MAGICOM MAIN LOGIC SCHEMATIC REVISIONS

"K" revision schematic is for "C" revision printed circuit board used with LDV-1000 laser disc player.

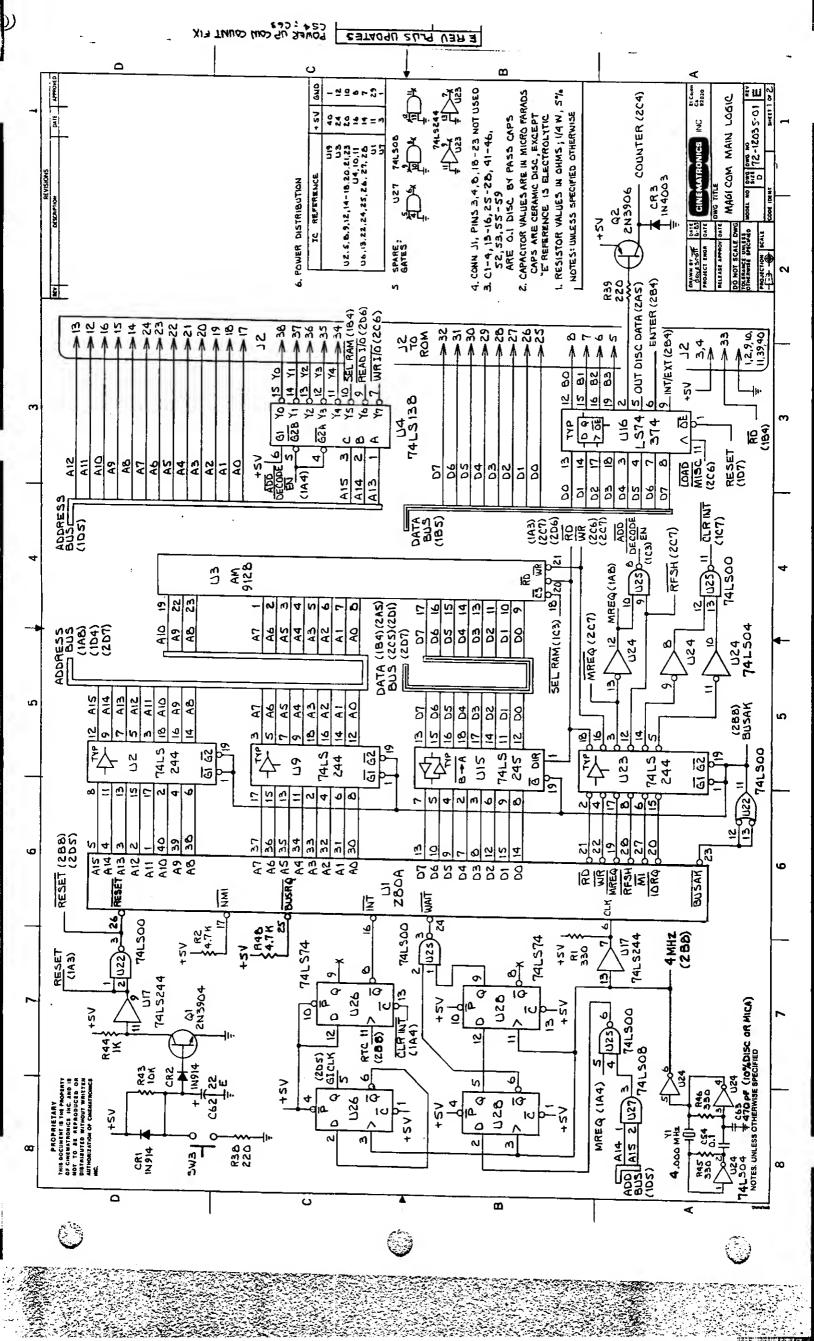
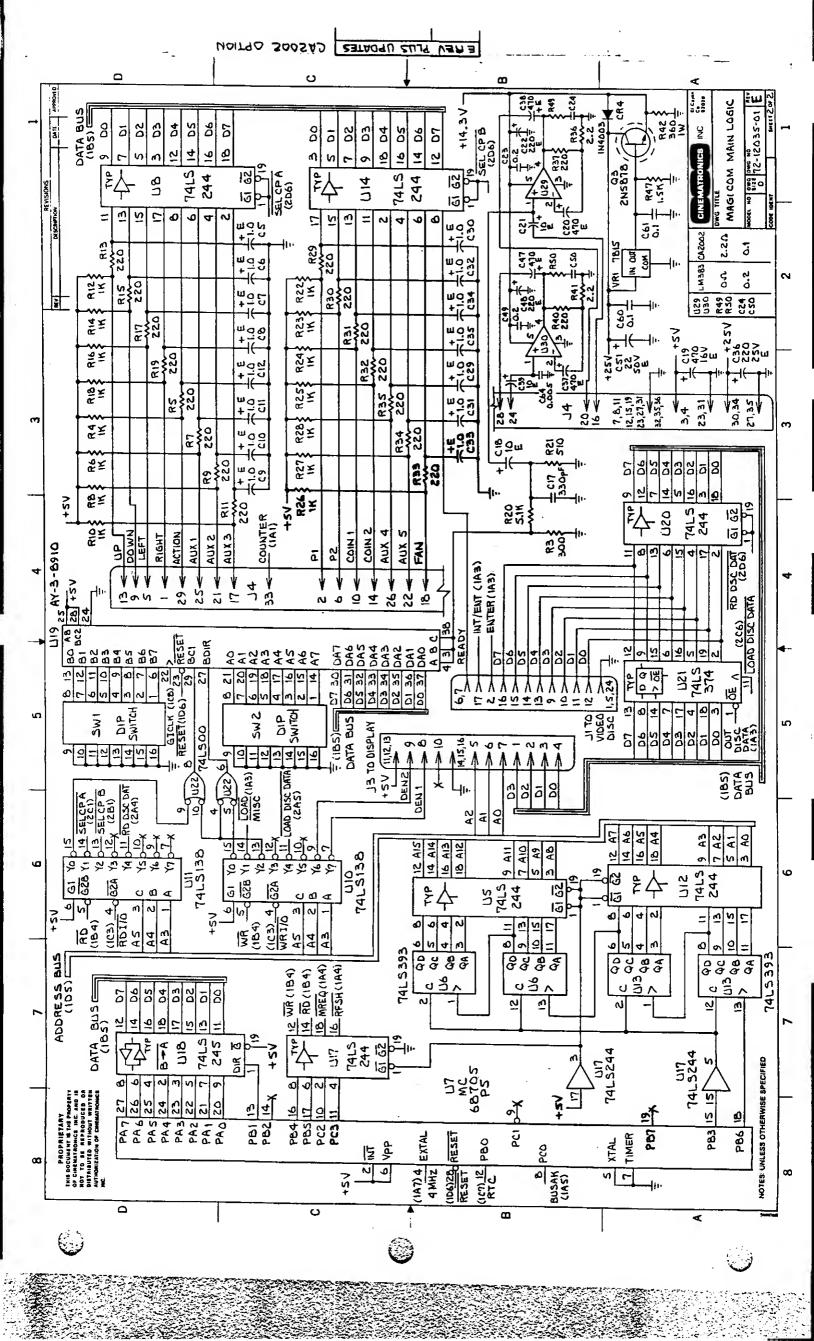
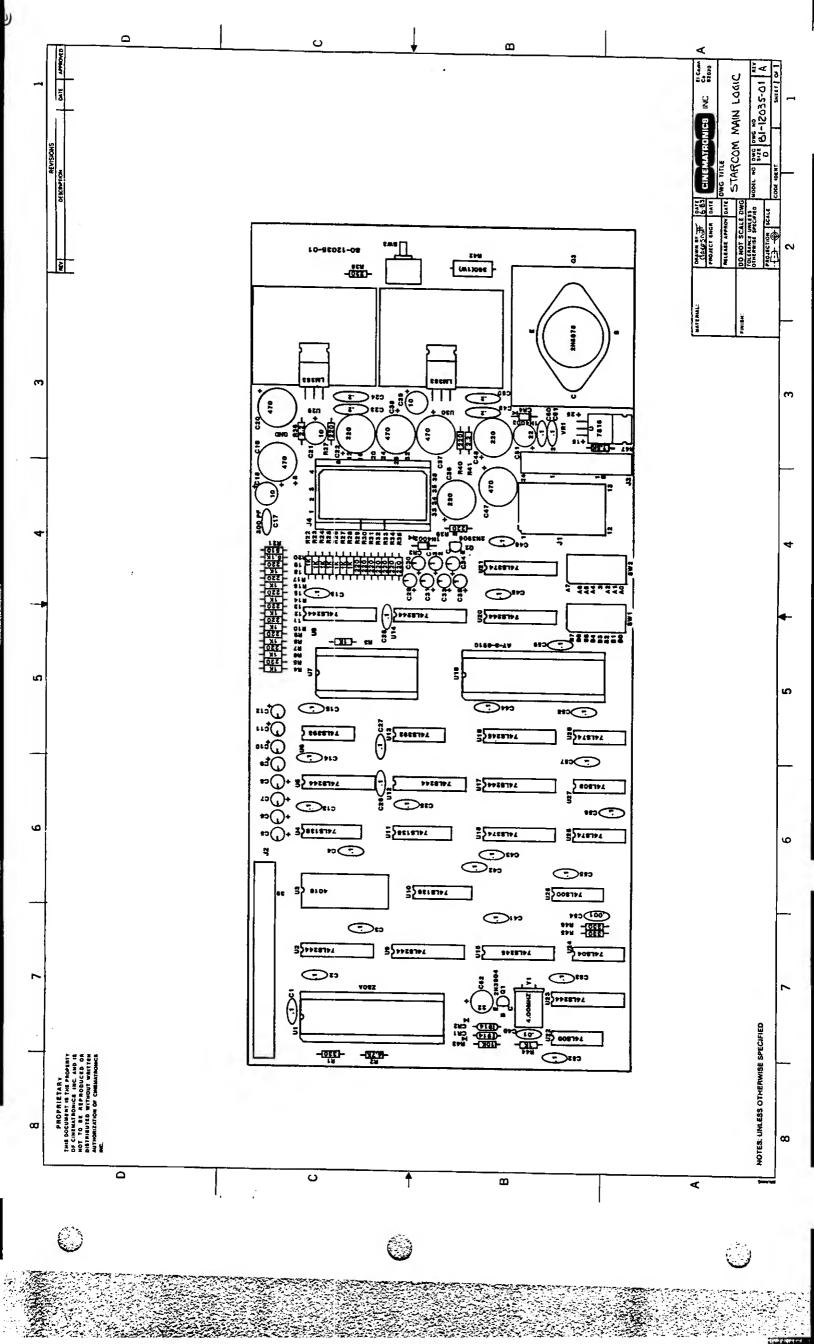
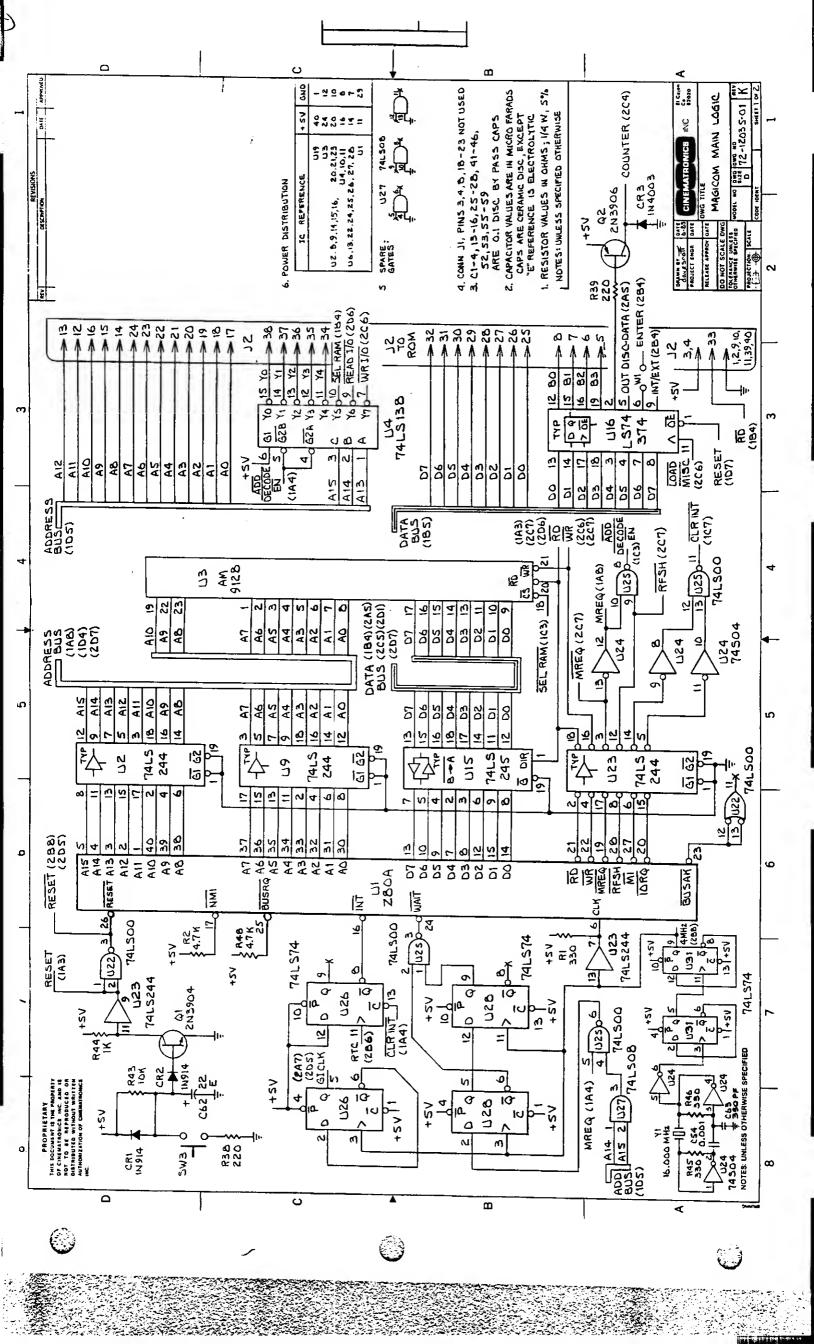
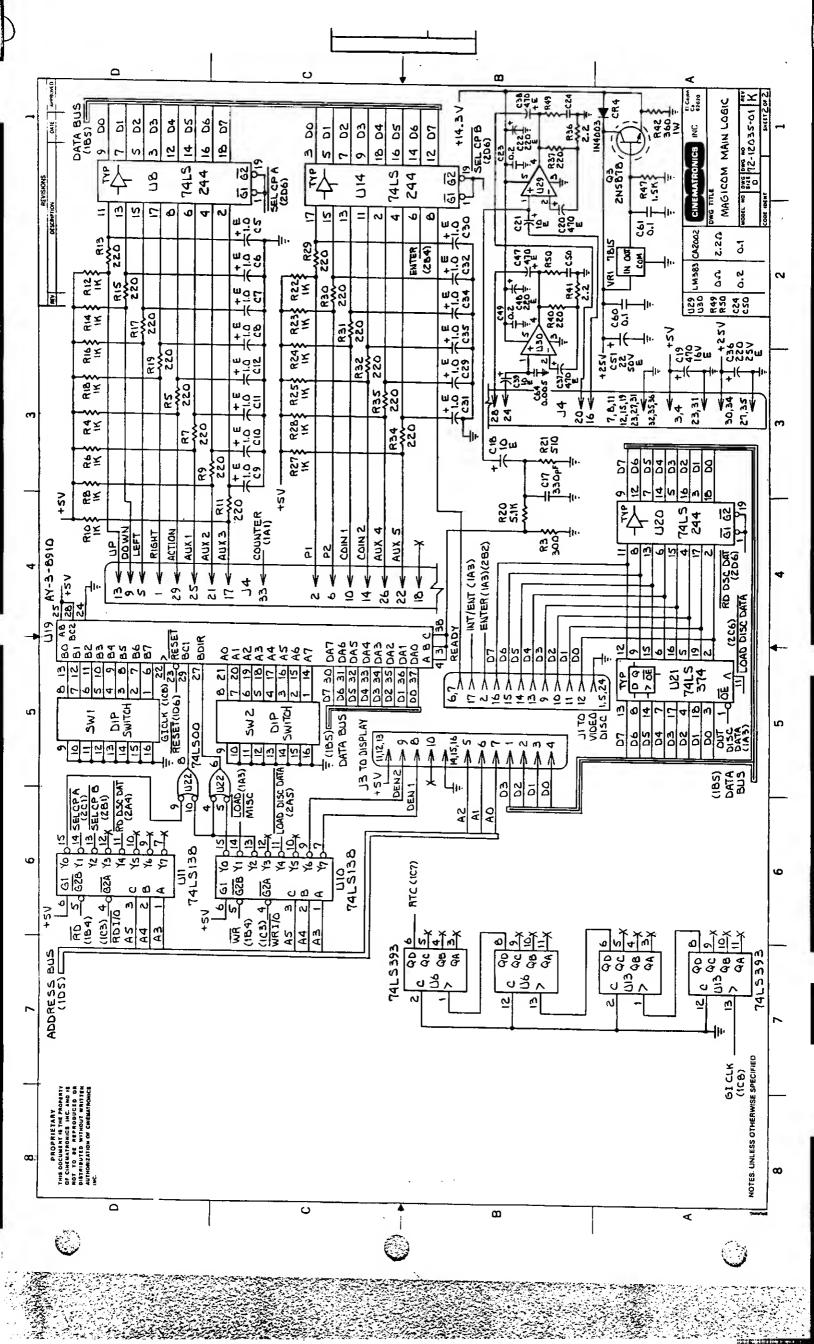
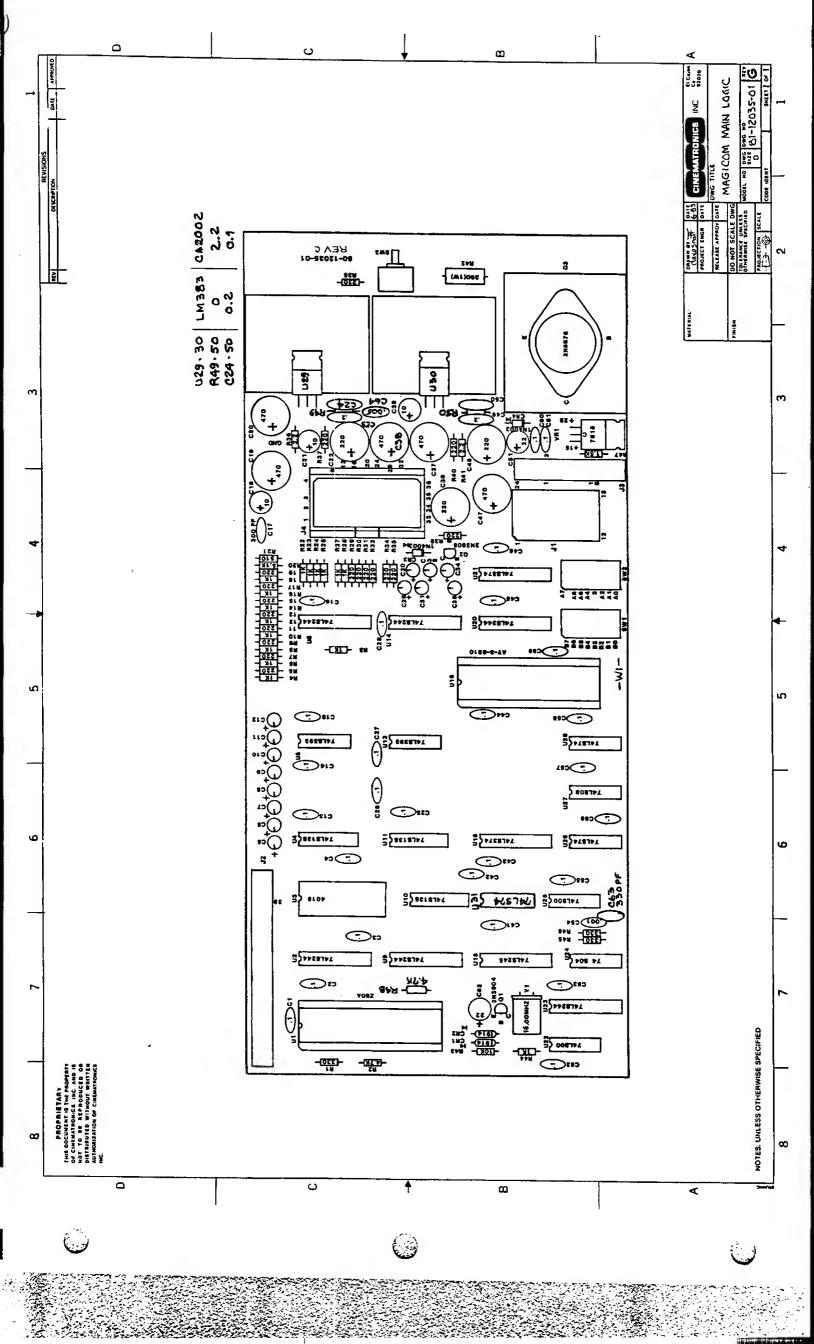
- A. Original release.
- B. R3: Was 1K; became 300.
 D0 on U20 incorrectly shown as Pin 8. Changed to pin 18 on 6/23/83.
- C. Addition of capacitor C63, 220pf disc between U24, Pin 3 and ground. 6/27/83.
- D. C54: Was 0.001uf disc. Became 0.1uf disc on 6/29/83.
 C63: Was 220pf disc. Became 0.001uf disc on 6/29/83.
 74LS244 inserted between 4MHz signal and U1 (280), Pin 6.
 U17, Pins 13 and 7 used these were formerly a spare gate.
 6/29/83.
- E. C40, 0.01 disc tied between U22, Pin 2 and ground is deleted. 74LS244 inserted between Q1 collector and U22, Pins 1 and 2. U17, Pins 11 and 9 used these were formerly a spare gate. U1(Z80), Pin 25 cut from U7 (MC68705P5), Pin 9. U1(Z80), Pin 25 tied to R48 (new addition) 4.7K ¼W 5% resistor. Other side of R48 tied to +5V.

Ul8(74LS245), Pin 19 cut from U7(68705, Pin 14. Ul8, Pin 19 tied to +5V.

Ul7(74LS244), Pin 17 cut from U7, Pin 19. Ul7, Pin 17 tied to +5V.

U23(74LS244), Pin 1 cut from U22(74LS00), Pin 11. U23, Pin 1 tied to ground.

- F. Deletion of the following effective 7/8/83:
 - U5 74LS244
 - U6 74LS393
 - U12 74LS244
 - U13 74LS393
 - U17 74LS244
 - U18 74LS245

Subtitute U23 for U17 (74LS244) for clock signal into Z80 (U1, Pin 6 from U23, Pin 7) and reset signal into U22, Pins 1 and 2 from U23, Pin 9 effective 7/8/83.

- G. C63: Was 0.00luf disc. Became 470pf effective 9/5/83.
- H. Reset signal sent from U23, Pin 9 to U16, Pin 1 to cure false coin count on power up.
- I. Reference letter not used.

- J. Correct pin out for inputs on U20(74LS244) effective 9/16/83.
- K. C63: Was 470pf disc; became 330pf disc.

C17: Was 330pf mica; became 330pf disc.

Addition of U31(74LS74) to divide clock.

Y1: Was 4.000MHz; became 16.000MHz.

U24: Was74LS04; became 74S04.

Addition of R29 between U29, Pin 4 and C24. Addition of R50 between U30, Pin 4 and C50.

Addition of Jumper W1, when installed, allows board to be used with Pioneer 7820 disc player with proper software.

Deleted: U7 MC68705

Addition (reinstallation) U6, 74LS393

Ul3, 74LS393

U6, Pins 2 and 12, and U13, Pins 2 and 12 all grounds.

U6, Pin 6 tied to U26, Pin 11 (RTC).

Ul3, Pin 13 tied to U26, Pin 5 (GI CLK)
